**DEMONSTRATION / DELIVERY HOLD - Safety Recall 16S06**  
Certain 2015-2016 Model Year Transit Wagon Vehicles  
Seat Belt Buckle Repair/Replacement

# VC 1 - 8 Passenger, Low Roof

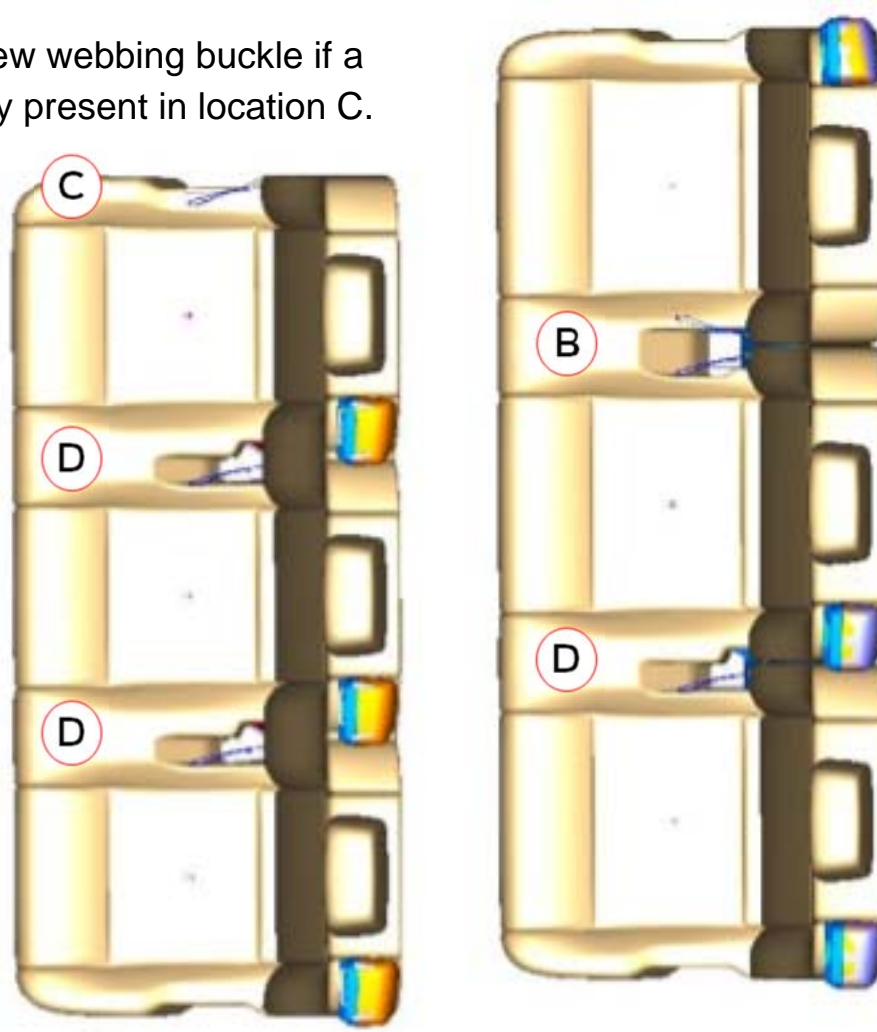
NOTE: Do not install a new webbing buckle if a webbing buckle is already present in location C.

- B** Replace Double Buckle - CK4Z-1460044-A - Qty. 1
- C** Install Webbing Buckle - BK3Z-6160044-A - Qty. 1

- D** Refer to Attachment III: Technical Information  
Inspect All LH Seat Belt Buckle/Retractor Assemblies  
Install 3 Reinforcement Blockers CK4Z-14613D10-B  
(1 package includes 5 pieces)

# VC 2 - 8 Passenger, Mid Roof

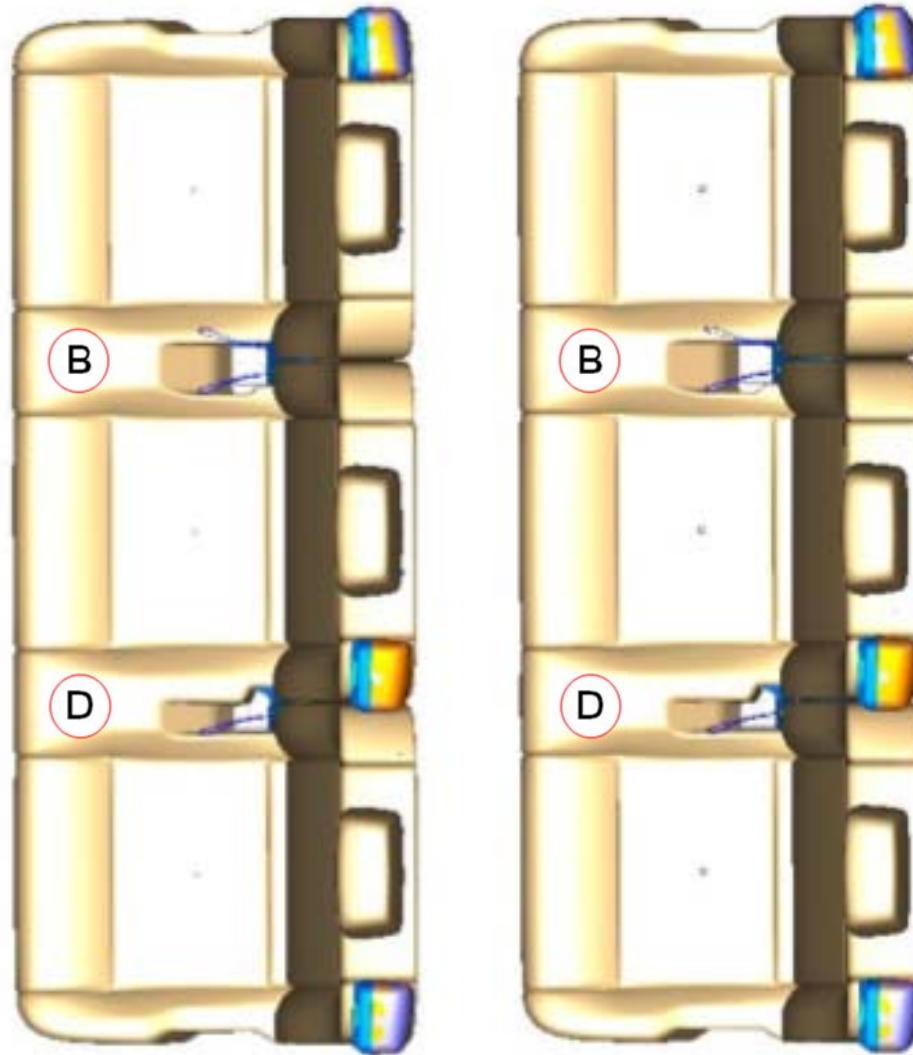
**B** Replace Double Buckle - CK4Z-1460044-A - Qty. 2

**D** Refer to Attachment III: Technical Information  
Inspect All LH Seat Belt Buckle/Retractor Assemblies  
Install 2 Reinforcement Blockers CK4Z-14613D10-B  
(1 package includes 5 pieces)

## VC 3 - 10 Passenger

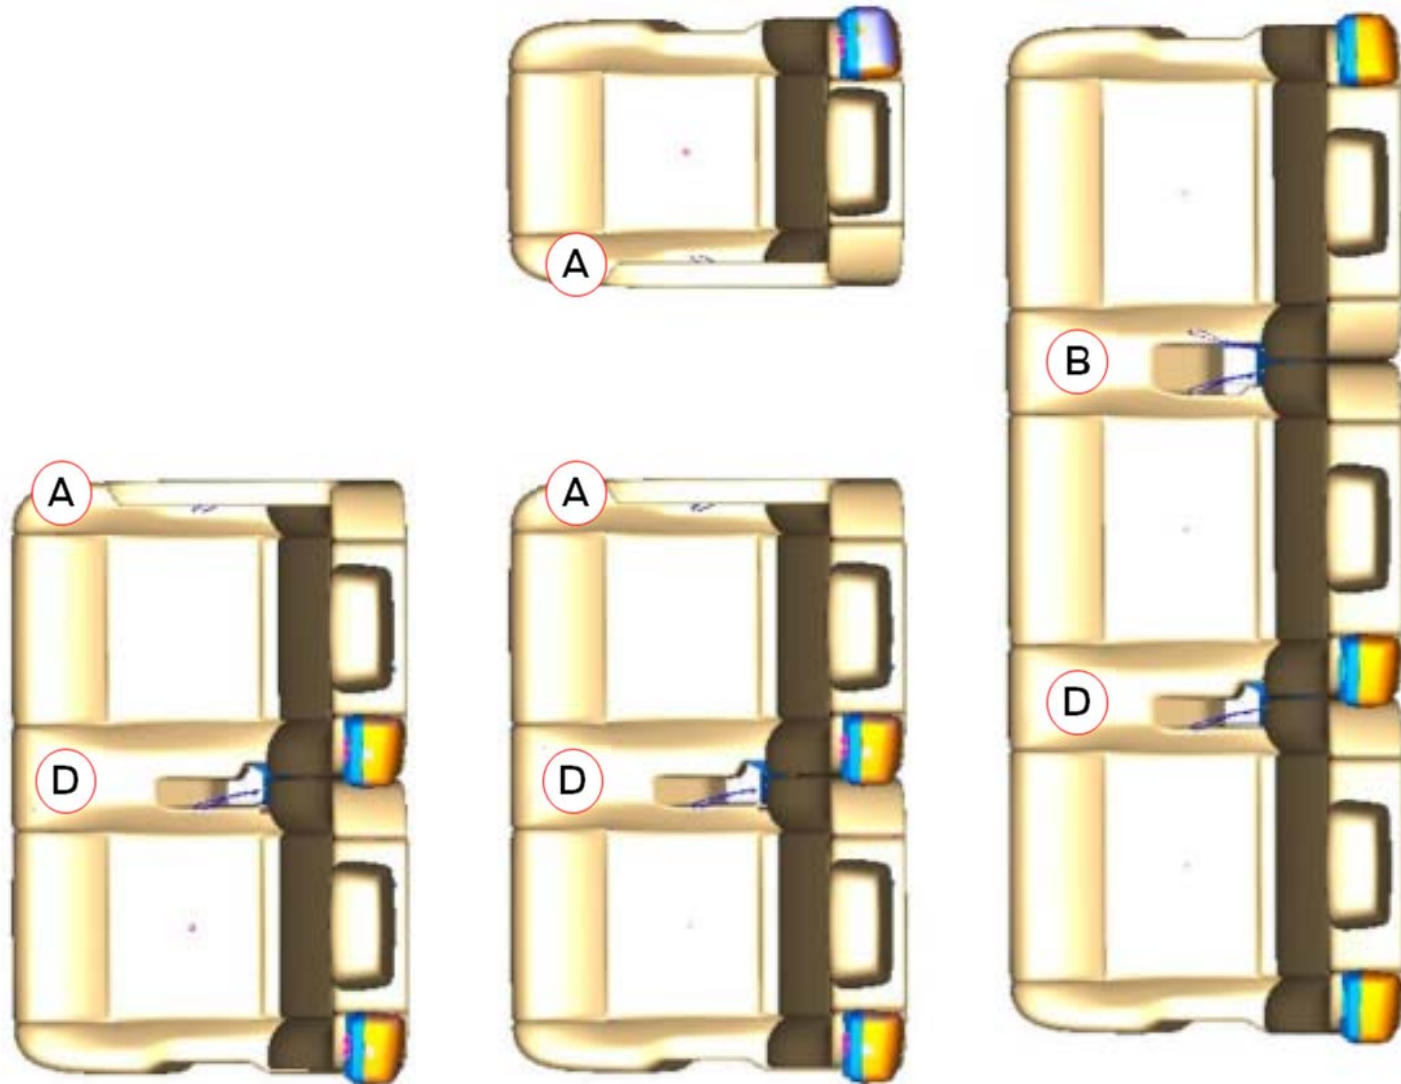
**A** Replace Single Buckle - CK4Z-1460044-B - Qty. 3

**B** Replace Double Buckle - CK4Z-1460044-A - Qty. 1

**D** Refer to Attachment III: Technical Information  
Inspect All LH Seat Belt Buckle/Retractor Assemblies  
Install 3 Reinforcement Blockers CK4Z-14613D10-B  
(1 package includes 5 pieces)

# VC 4 - 12 Passenger

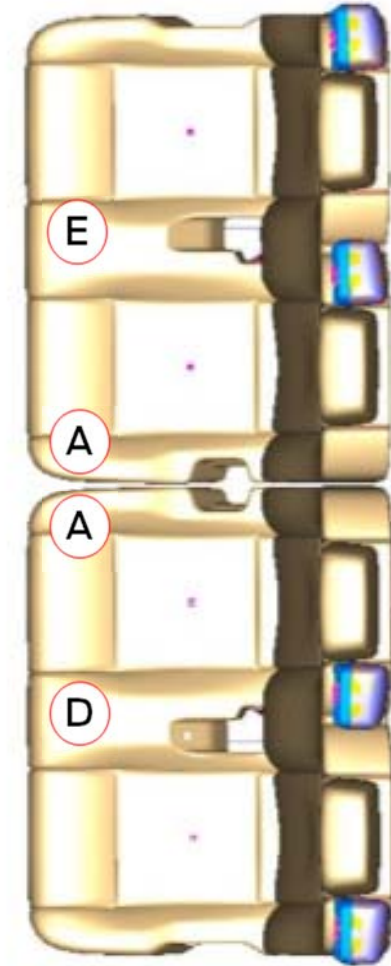
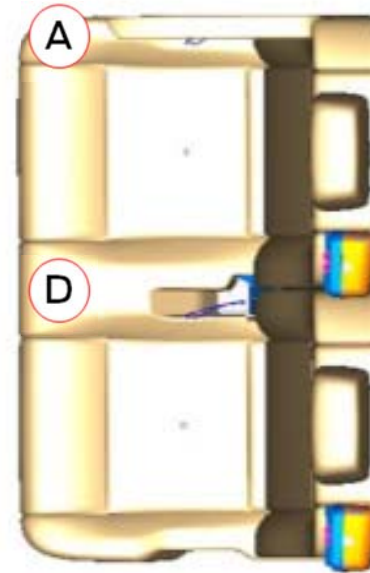
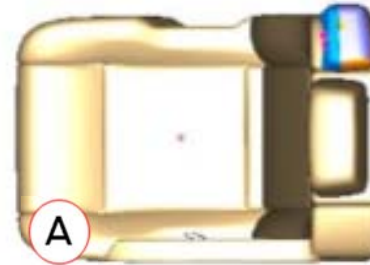
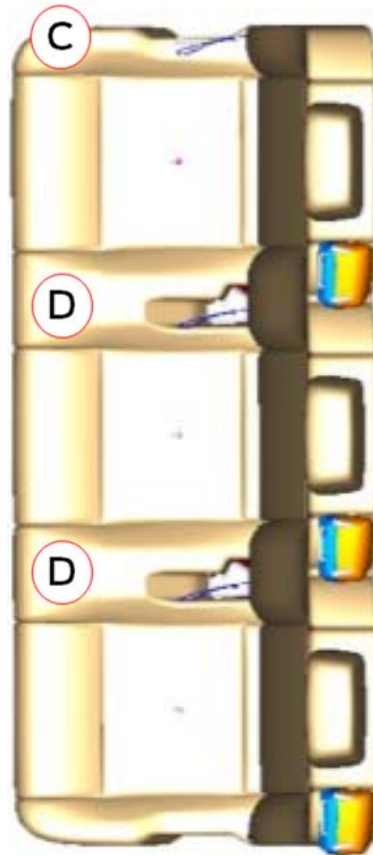
NOTE: Do not install a new webbing buckle if a webbing buckle is already present in location C.

- A** Replace Single Buckle - CK4Z-1460044-B - Qty. 4
- C** Install Webbing Buckle - BK3Z-6160044-A - Qty. 1

- Refer to Attachment III: Technical Information
- D** Inspect All LH Seat Belt Buckle/Retractor Assemblies
  - E** Inspect All RH Seat Belt Buckle/Retractor Assemblies
- Install 5 Reinforcement Blockers CK4Z-14613D10-B  
(1 package includes 5 pieces)

# VC 5 - 15 Passenger

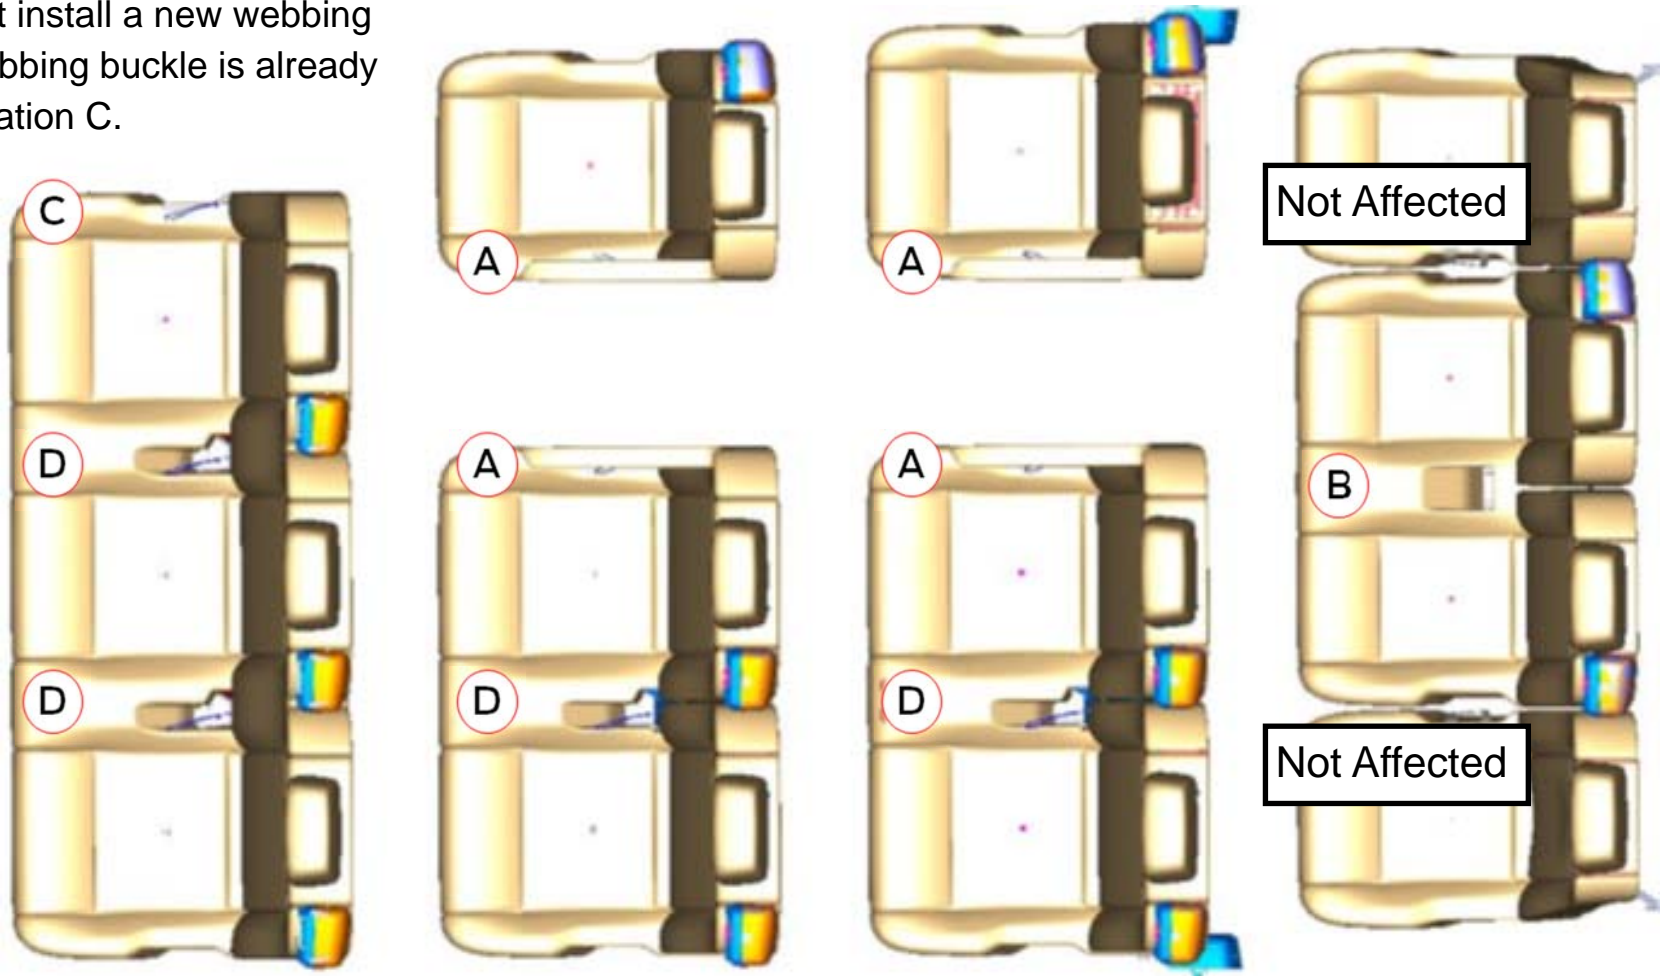
NOTE: Do not install a new webbing buckle if a webbing buckle is already present in location C.

- A** Replace Single Buckle - CK4Z-1460044-B - Qty. 4
- B** Replace Double Buckle - CK4Z-1460044-A - Qty. 1
- C** Install Webbing Buckle - BK3Z-6160044-A - Qty. 1

- D** Refer to Attachment III: Technical Information  
Inspect All LH Seat Belt Buckle/Retractor Assemblies  
Install 4 Reinforcement Blockers CK4Z-14613D10-B  
(1 package includes 5 pieces)

# VC 6 - 15 Passenger, Extended-Length

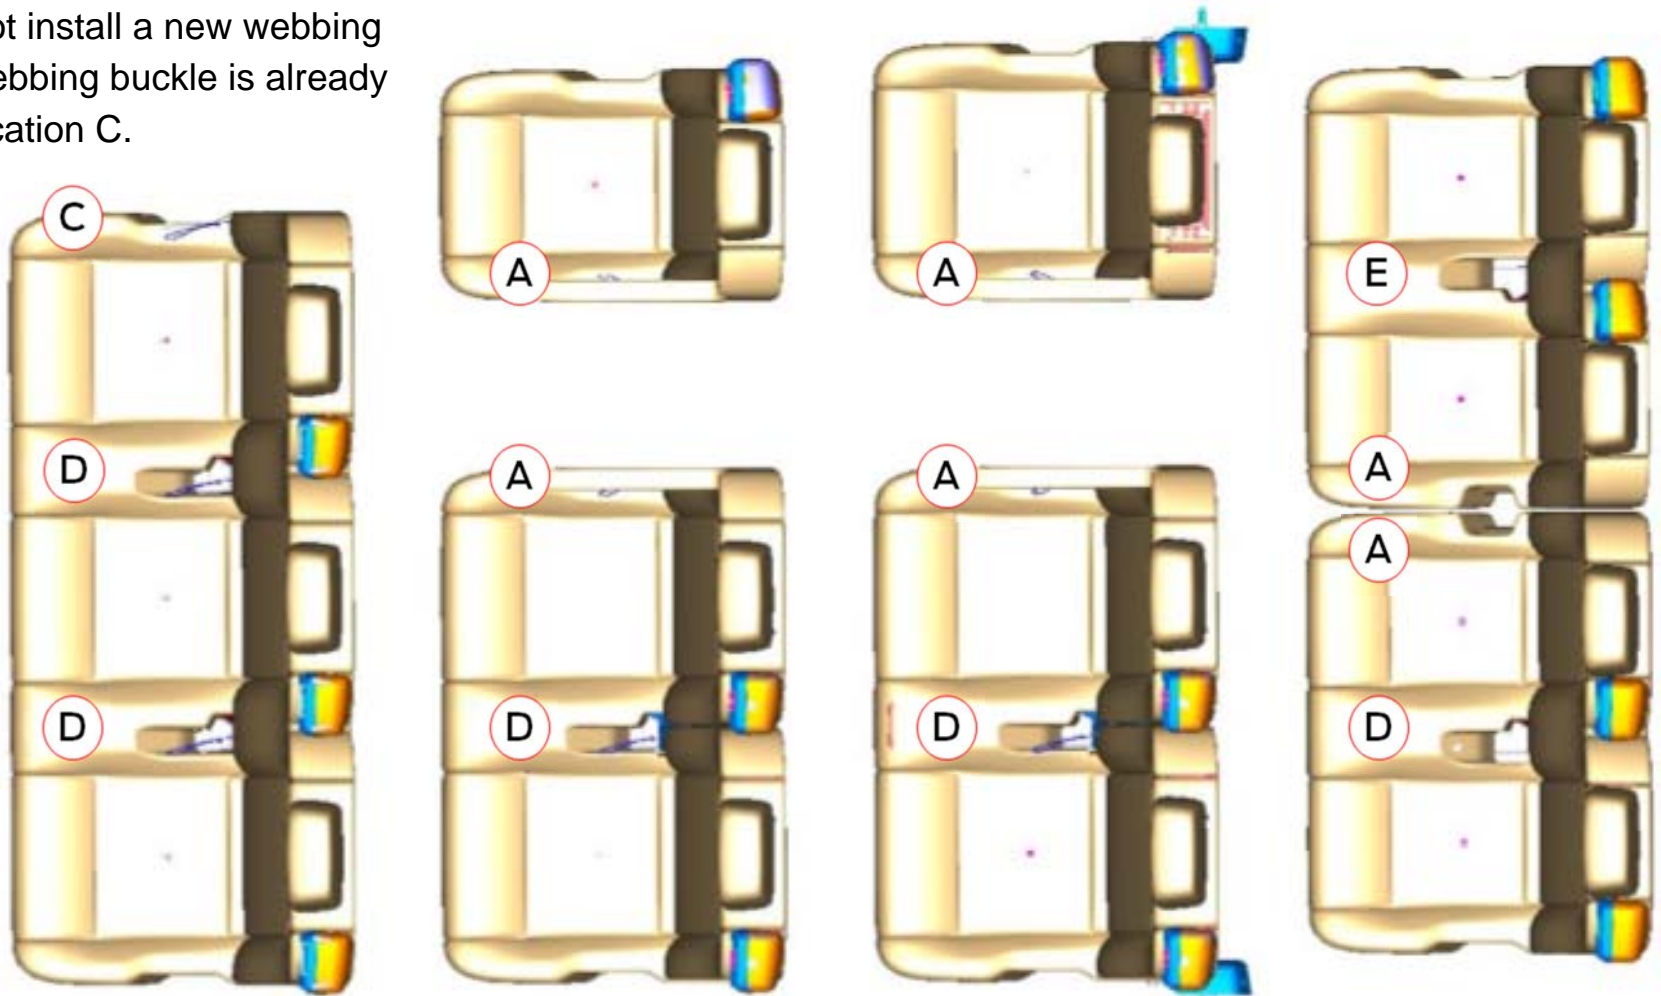
NOTE: Do not install a new webbing buckle if a webbing buckle is already present in location C.

- A** Replace Single Buckle - CK4Z-1460044-B - Qty. 6
- C** Install Webbing Buckle - BK3Z-6160044-A - Qty. 1

- D** Inspect All LH Seat Belt Buckle/Retractor Assemblies
  - E** Inspect All RH Seat Belt Buckle/Retractor Assemblies
- Install 6 Reinforcement Blockers CK4Z-14613D10-B  
(1 package includes 5 pieces)
